**ADDENDUM NO. 1
NEW ELEVATOR
AT MURPHY ELEMENTARY SCHOOL
ROUND LAKE SCHOOL DISTRICT NO. 116
PROJECT NO. 23170**

Board of Education
Round Lake School District 116
884 West Nippersink Road
Round Lake, Illinois 60073

P1.0

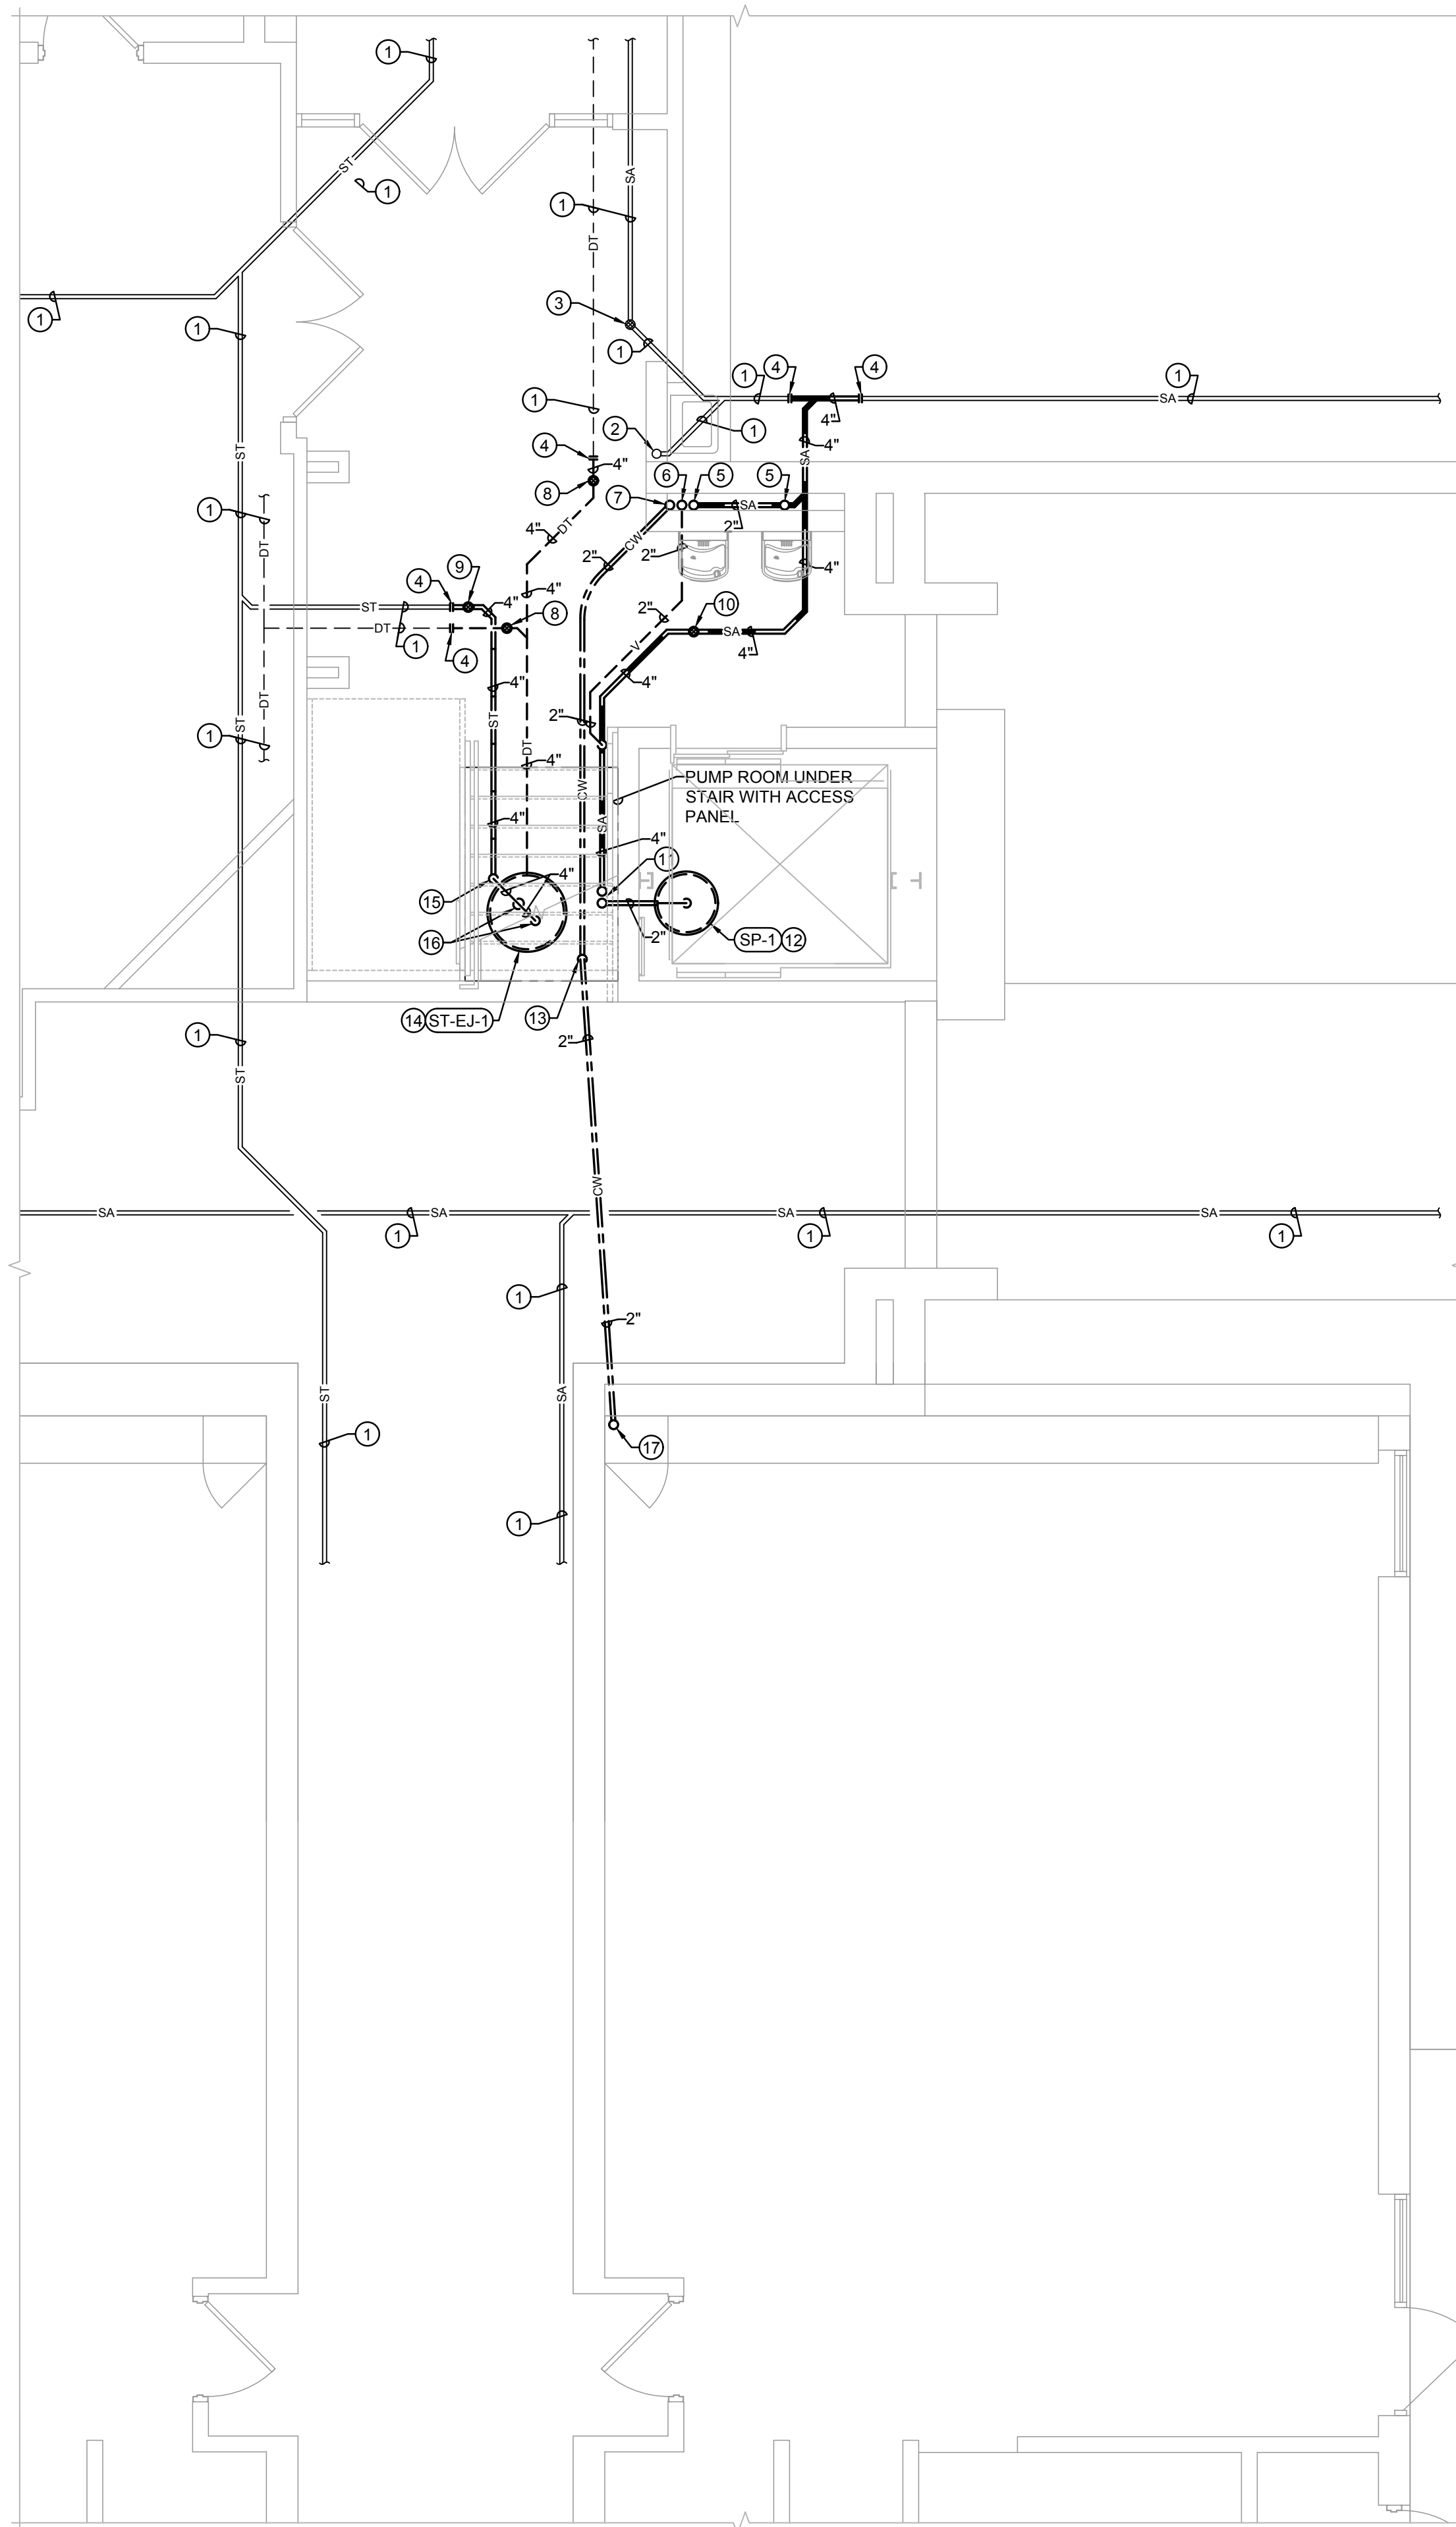
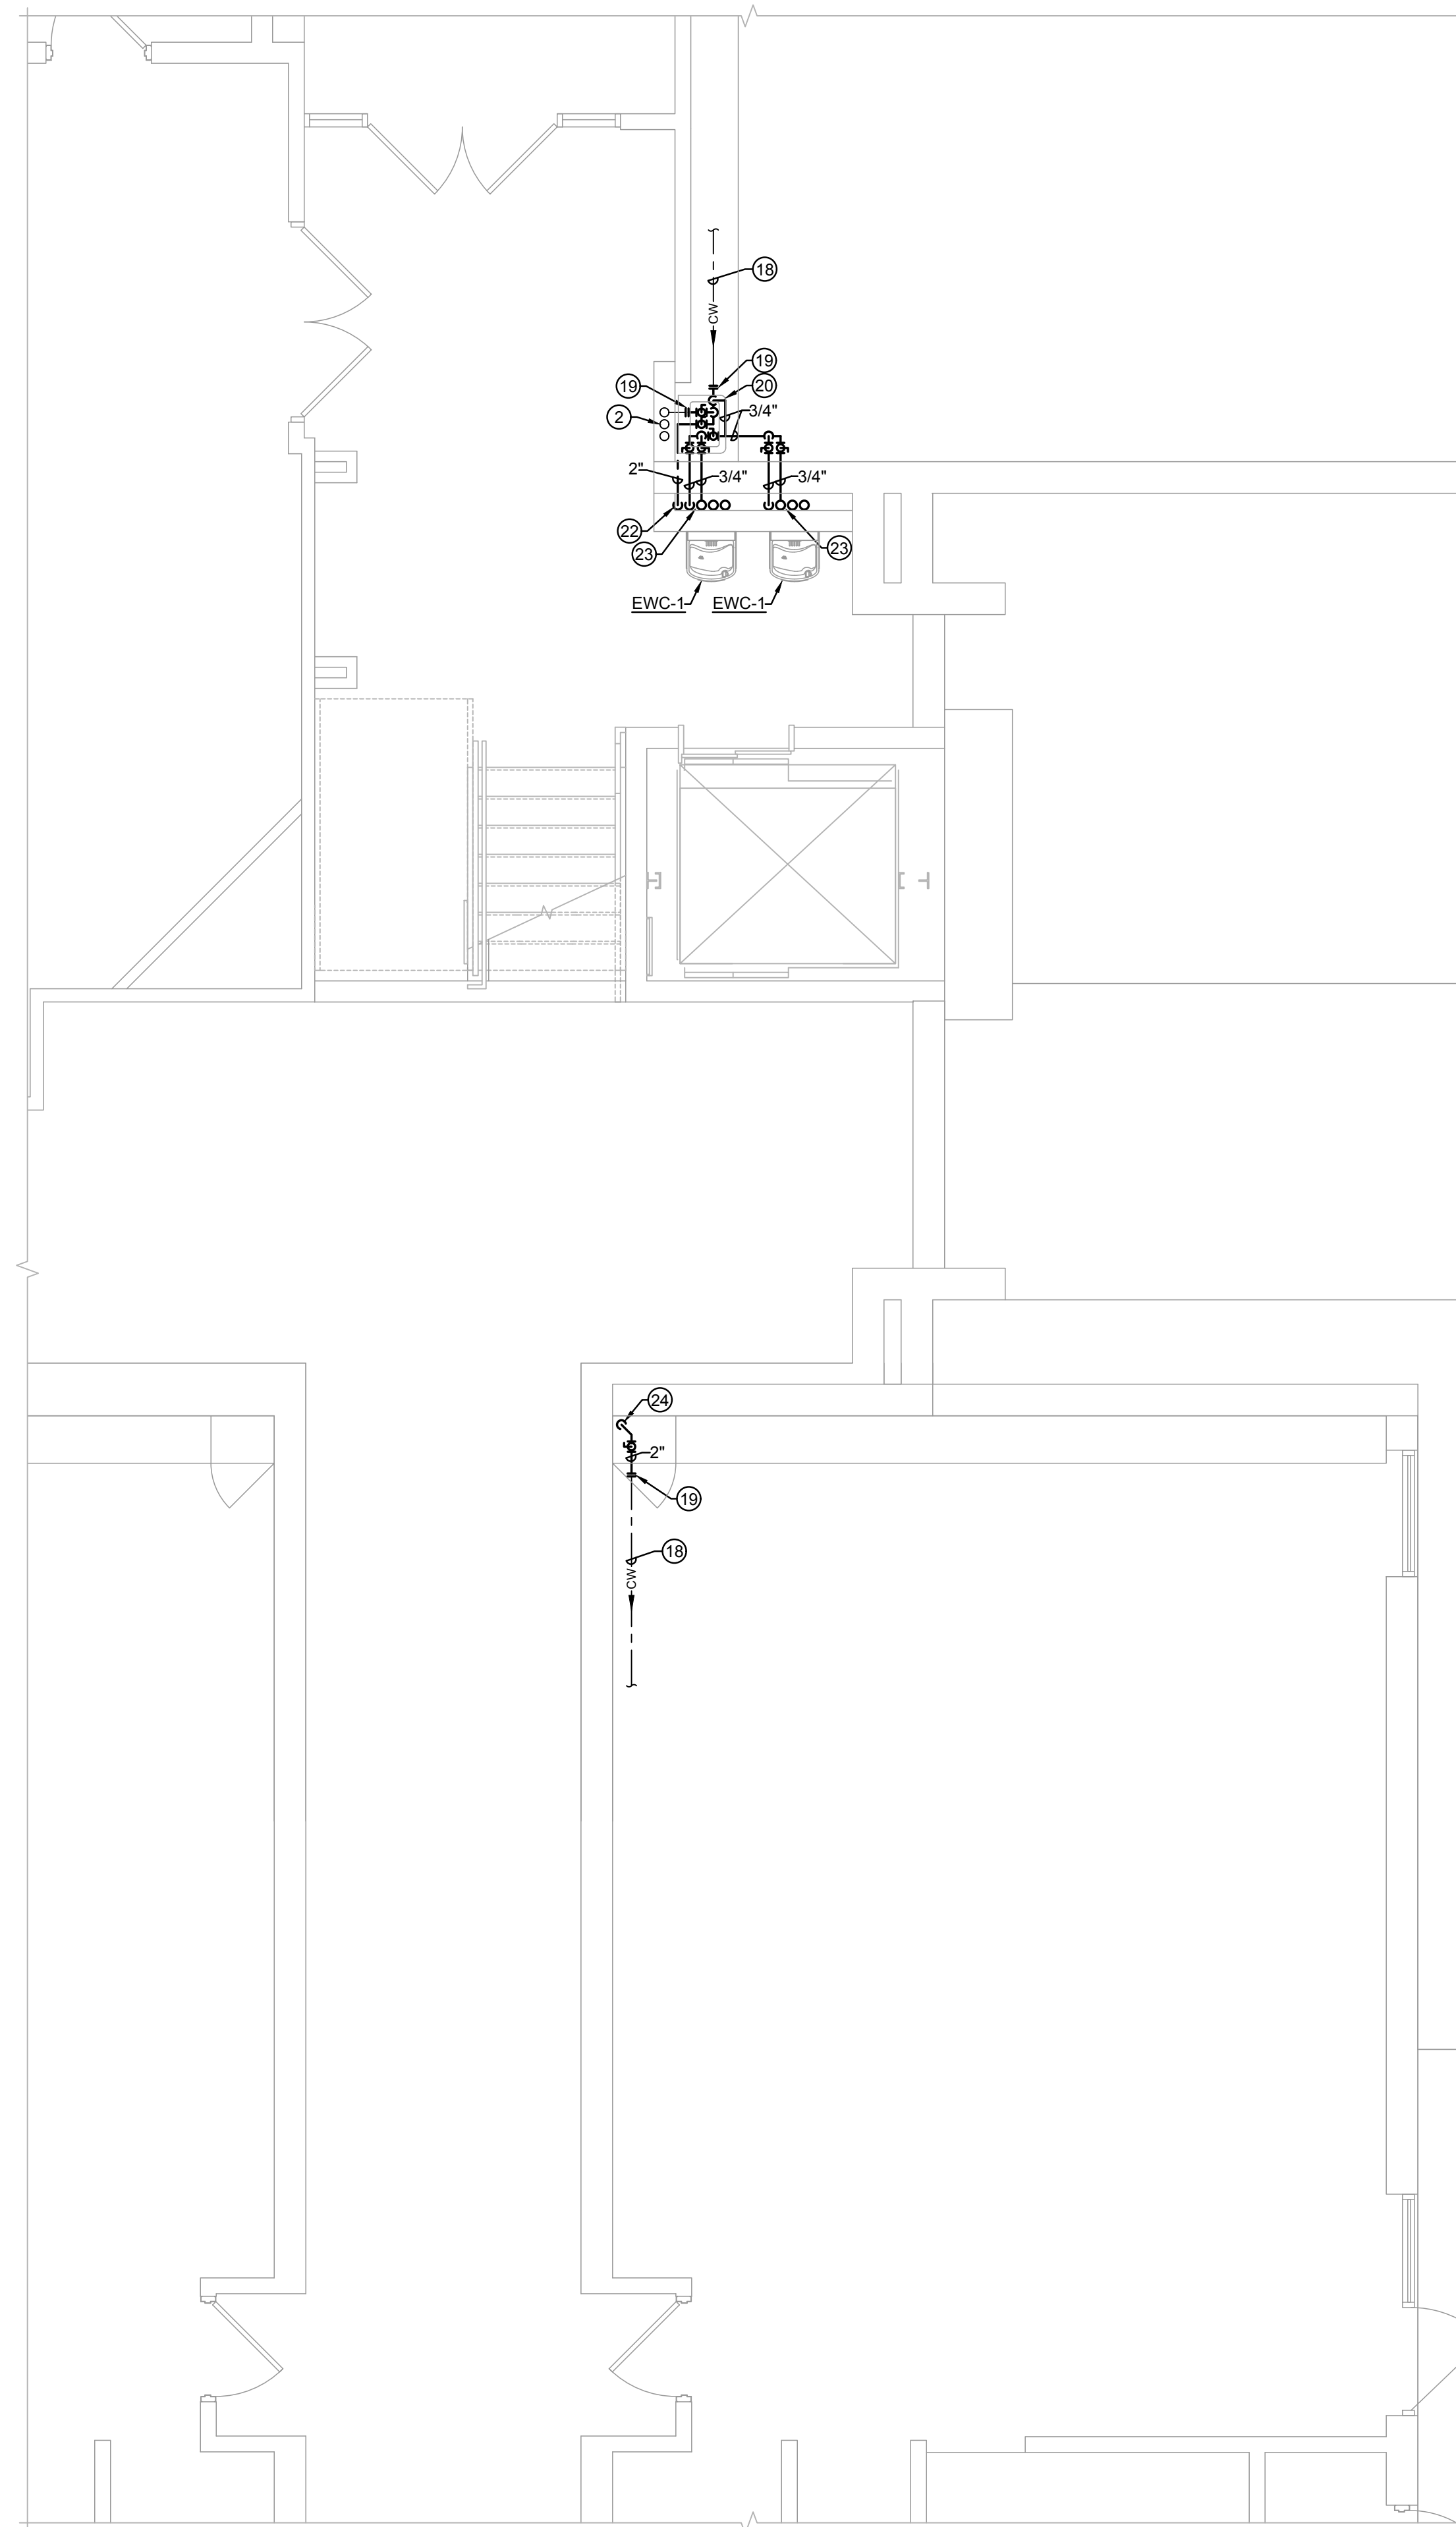
ITEM NO. 8: PROJECT DRAWINGS, P1.0, PARTIAL PLUMBING PLANS

1. Refer to attached drawing P1.0 and refer to highlighted items for updates.
